6813B-06

# <u>SERVICE NOTE</u>

# 6813B AC SOURCE/ANALYZER, 0-300 VRMS,1750 VA, SINGLE-PHASE. GPIB, RS-232.

Figure 5 Figure 6

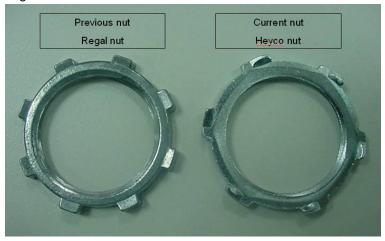
Figures 3 & 5 is representative of a not without locking ribs.

Figure 5 4 & 6 is representative of a nut with locking ribs.

The entire AC INPUT SAFETY COVER P/N 5040-1676 should be replaced.

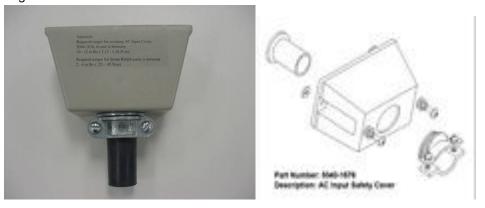
The line cord should also be securely fastened at a point 6 to 12 inches away from **INPUT SAFETY COVER** as shown in <u>Figure 7</u>. When this type of strain relief is used the electrical code requires the cord/cable being held by the strain relief be secured. Doing this eliminates the cable or cord from being twisted as shown in figure 1.
